From: Rose Zoia <rzoia@sbcglobal.net>
Sent: Tuesday, February 27, 2018 4:41 PM
To: Madolyn Agrimonti; David@cvmgrapes.com; City Council; Gary Edwards; Amy Harrington; Rachel Hundley
Cc: Cathy Capriola; 'Jeff Walter'; David Goodison
Subject: RE: RE: Brazil Street/4th St E project - March 1, 2018 hearing
Attachments: Machi letters final.pdf

Subject: 149 Fourth Street East – Lower Lot 2 - Residence

Subject: **Lot 227 (Brazil Street Lot 4)**

Subject: Lot 228 (Brazil Street Lot 3)

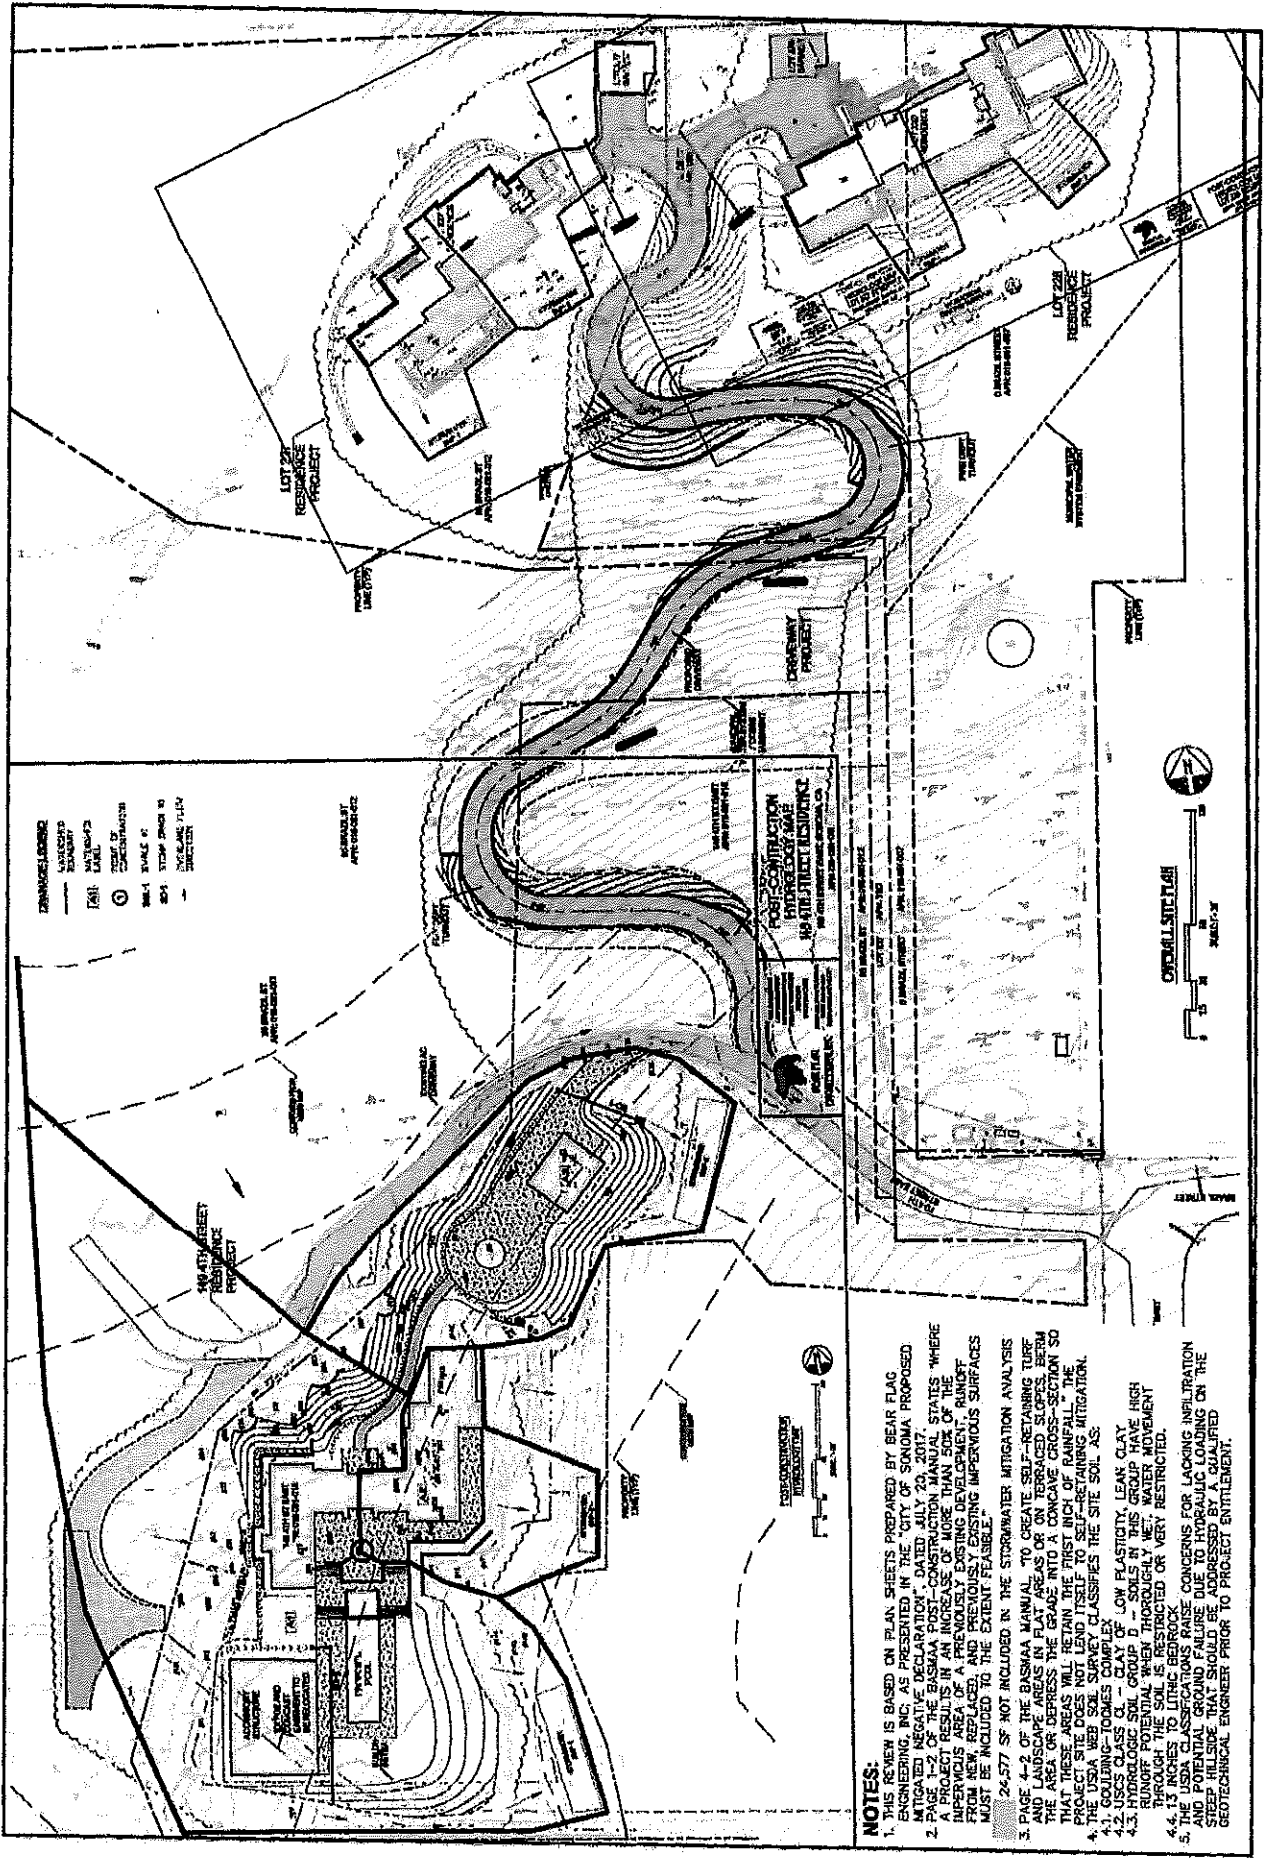
- City Code table 3-3 stats that R-HS zones projects may not exceed 15% in site coverage. We have measured the coverage to be 20.4%. Please see our attached exhibit.
- 19.40.050.E.6. States that *"Retaining walls that result in large uniform planes shall be avoided... Generally, no retaining wall should be higher than five feet."* The stem walls resulting from elevated footing construction have the same visual effect as retaining walls and appear to exceed 5 ft in height. Breaking them up and screening are recommended.

- 24,935 SF LOT COVERAGE (20.4% SITE COVERAGE)

POST-CONSTRUCTION HYDROLOGY MAP
109 4TH STREET RESIDENCE
 BEAR FLAG ENGINEERING, INC.
 109 4TH STREET, SONOMA, CA 94960
 DATE: 7/20/17

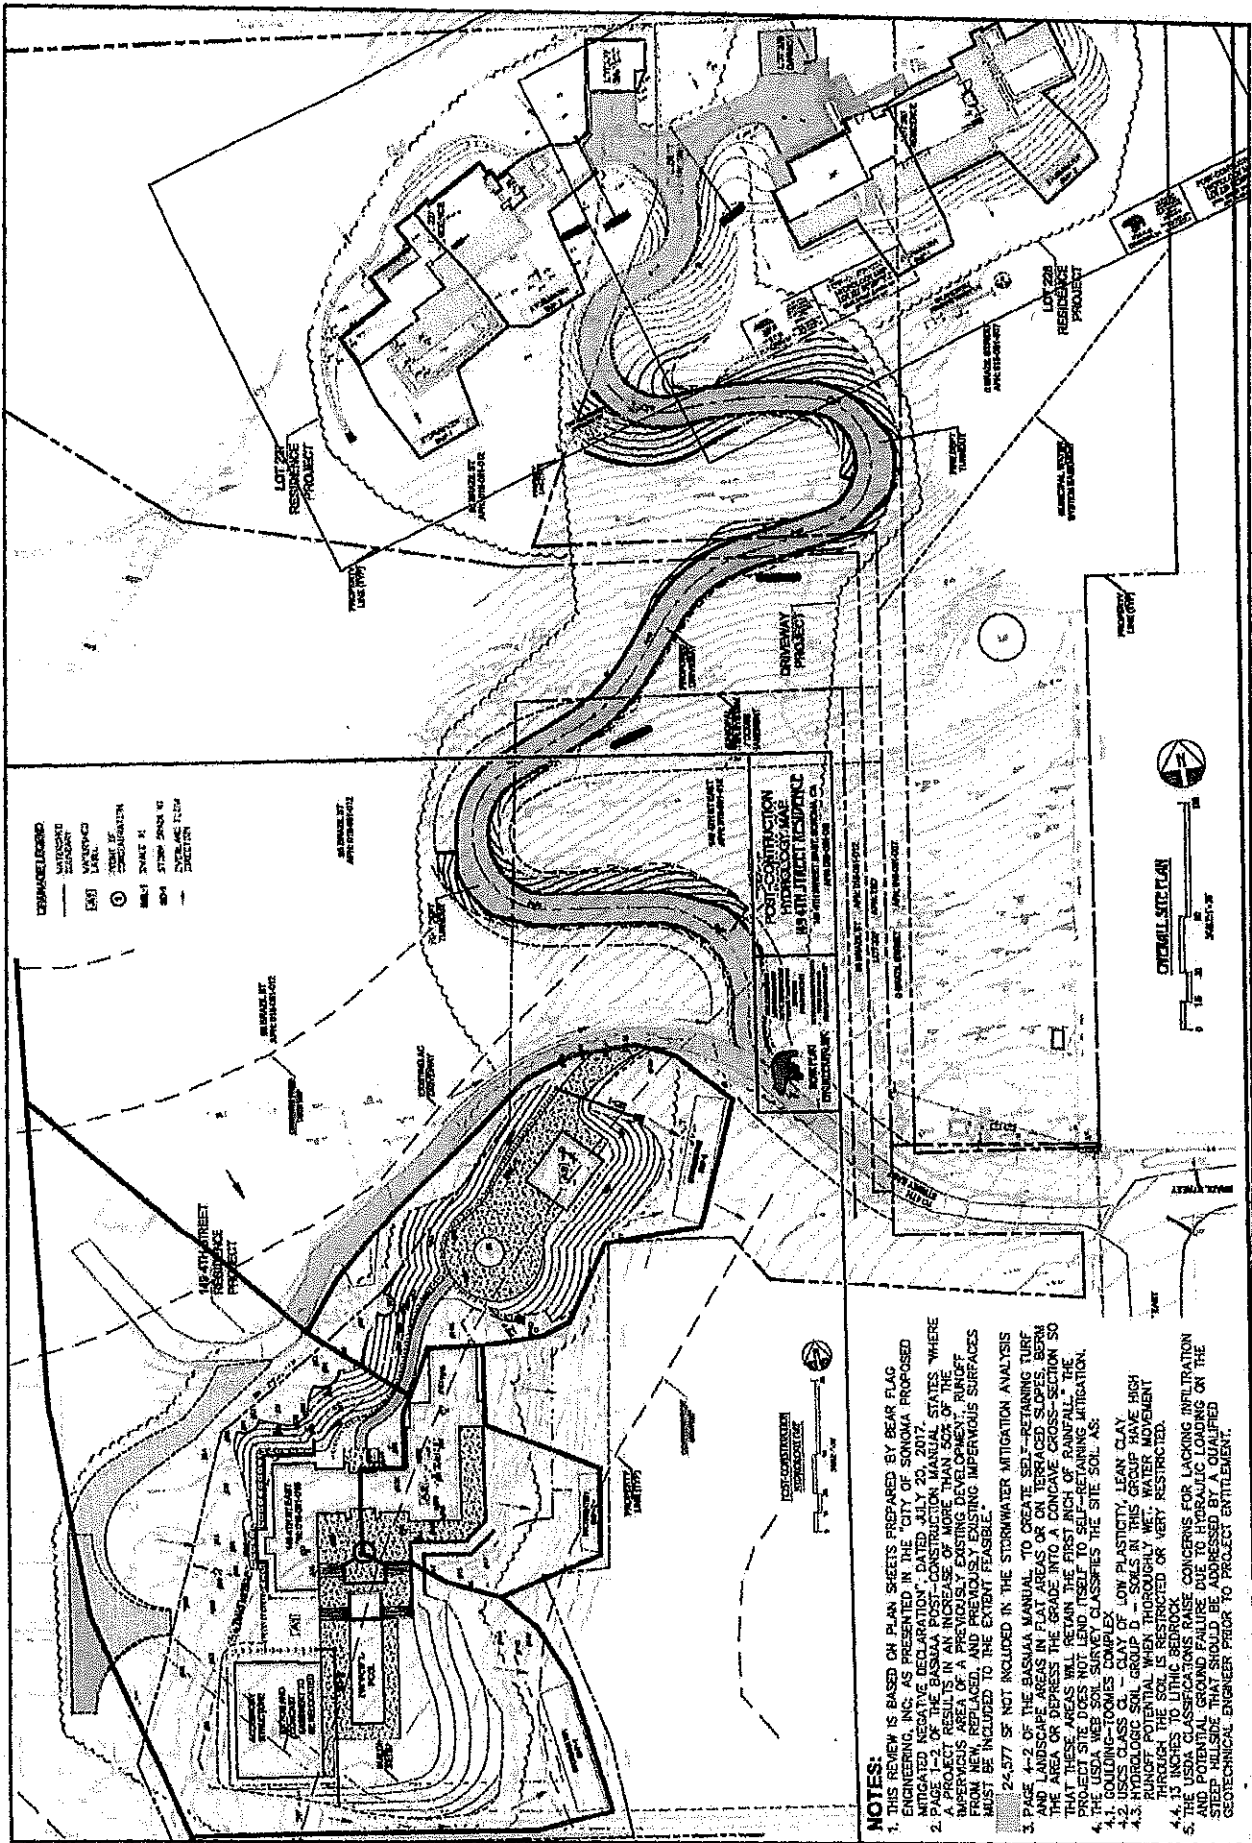
- The BASMAA Post-Construction Manual "where a project results in an increase of more than 50% of the impervious area of a previously existing development, **runoff from new, replaced, and previously existing impervious surfaces must be included** to the extent feasible." It appears that there are areas of existing and proposed impervious improvements that are not being directed to stormwater mitigation. Please see my attached exhibit.

1. THIS REVIEW IS BASED ON PLAN SHEETS PREPARED BY BEAR FLAG ENGINEERING, INC. AS PRESENTED IN THE CITY OF PORTLAND PLANS 1-2 FOR THE BASMAA POST-CONSTRUCTION MANUAL STATES WHERE A PROJECT RESULTS IN AN INCREASE OF MORE THAN 50% OF THE IMPERVIOUS AREA OF A PREVIOUSLY EXISTING DEVELOPMENT, RUNOFF FROM NEW, REPLACED, AND PREVIOUSLY EXISTING IMPERVIOUS SURFACES MUST BE INCLUDED TO THE EXTENT FEASIBLE.

2. 24-577 SF NOT INCLUDED IN THE STORMWATER MITIGATION ANALYSIS
3. PAGE 4-2 OF THE BASMAA MANUAL TO CREATE SELF-RETAINING TURF AND LANDSCAPE AREAS IN FLAT AREAS OR ON TERRACED SLOPES, BERM AND THE AREA OR DEPRESS THE GRADE INTO A CONCAVE CROSS-SECTION SO THAT THESE AREAS WILL RETAIN THE FIRST INCH OF RAINFALL. THE IMPERVIOUS SURFACES TO BE REPLACED OR REMOVED FOR MITIGATION.

4. THE USDA SOIL SURVEY CLASSIFIES THE SITE SOIL AS:
 - 4.1. GOULDING-TOOMES COMPLEX
 - 4.2. USCS CLASS CL - CLAY OF LOW PLASTICITY, LEAN CLAY
 - 4.3. HYDROLOGIC SOIL GROUP D - SOILS IN THIS GROUP HAVE HIGH RUNOFF POTENTIAL WHEN THOROUGHLY WET. WATER MOVEMENT THROUGHOUT THE SOIL PROFILE IS RESTRICTED.

- 4.4. 13 INCHES TO LITHIC BEDROCK
5. THE USDA CLASSIFICATIONS RAISE CONCERNS FOR LACKING INFILTRATION AND POTENTIAL GROUND FAILURE DUE TO HYDRAULIC LOADING ON THE STEEP HILLSIDE THAT SHOULD BE ADDRESSED BY A QUALIFIED GEOTECHNICAL ENGINEER PRIOR TO PROJECT ENTIREMENT.

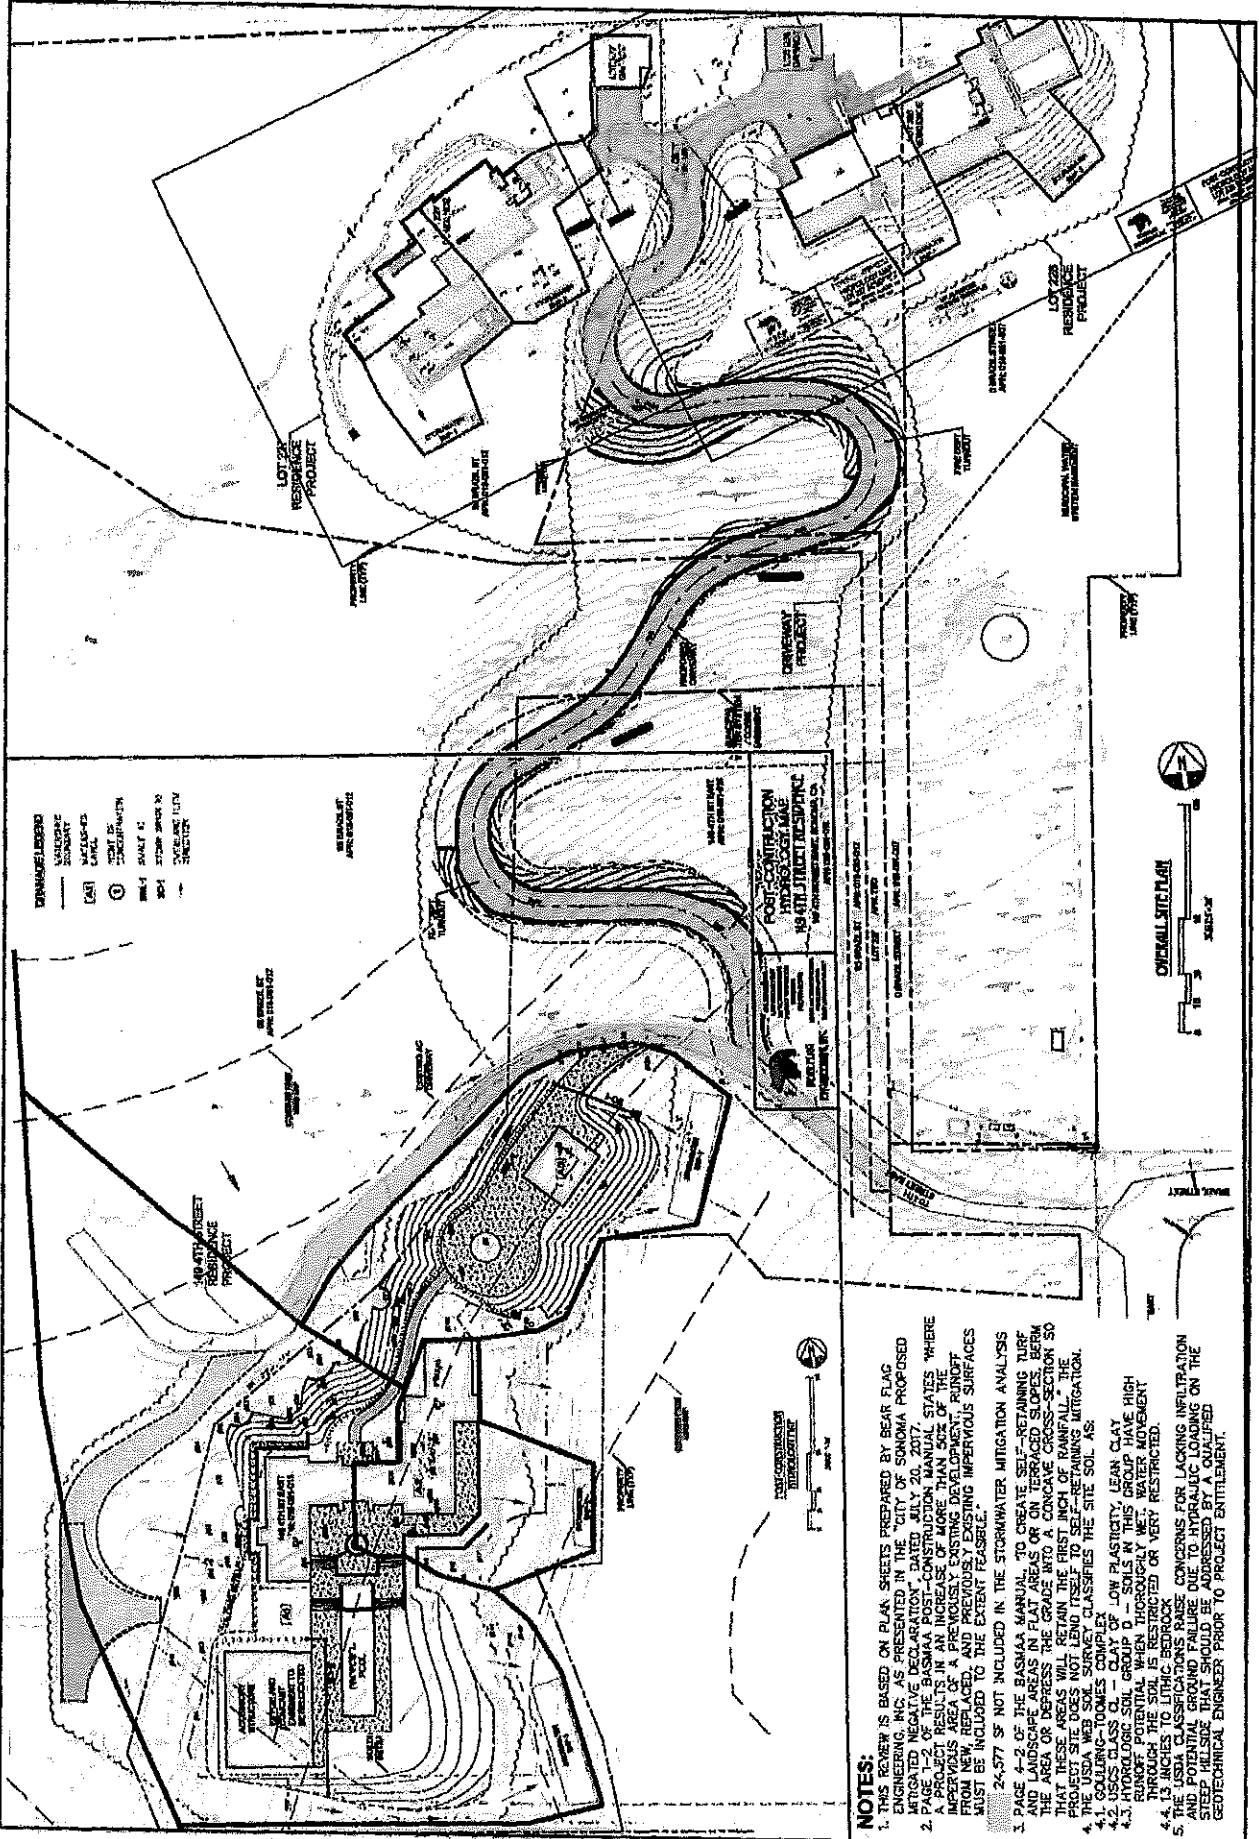
- The BASMAA Post-Construction Manual "where a project results in an increase of more than 50% of the impervious area of a previously existing development, **runoff from new, replaced, and previously existing impervious surfaces must be included** to the extent feasible." It appears that there are areas of existing and proposed impervious improvements that are not being directed to stormwater mitigation. Please see my attached exhibit.

2. PAGE 4-2 OF THE BASHAA MANUAL, "TO CREATE SELF-RETAINING TIER AND LANDSCAPE AREAS IN FLAT AREAS OR ON TERRACED SLOPES, BERM THE AREA OR DEPRESS THE GRADE INTO A CONCAVE CROSS-SECTION SO THAT THESE AREAS WILL RETAIN THE FIRST INCH OF RAINFALL." THE PROJECT SITE DOES NOT LEAD ITSELF TO SELF-RETAINING MITIGATION.

3. 24-577 SF NOT INCLUDED IN THE STORMWATER MITIGATION ANALYSIS
4. 1. CALIFORNIA ZONES COMPLEX - CLASSIFIES THE SITE SOIL AS:
 - 4.1 USCS CLASS CL - CLAY OF LOW PLASTICITY, LEAN CLAY

- 4.2 HYDROLOGIC SOIL GROUP D - SOILS IN THIS GROUP HAVE HIGH RUNOFF POTENTIAL WHEN THOROUGHLY WET. WATER MOVEMENT THROUGH THE SOIL IS RESTRICTED OR VERY RESTRICTED.

- 4.3 USCS CLASS CL - CLAY OF LOW PLASTICITY, LEAN CLAY
 - 4.4 USCS CLASS CL - CLAY OF LOW PLASTICITY, LEAN CLAY
5. THE USDA CLASSIFICATION RISES CONCERNS FOR LACKING INFILTRATION AND POTENTIAL GROUND FAILURE DUE TO HYDRAULIC LOADING ON THE STEEP HILLSIDE THAT SHOULD BE ADDRESSED BY A QUALIFIED GEOTECHNICAL ENGINEER PRIOR TO PROJECT ENTITLEMENT.
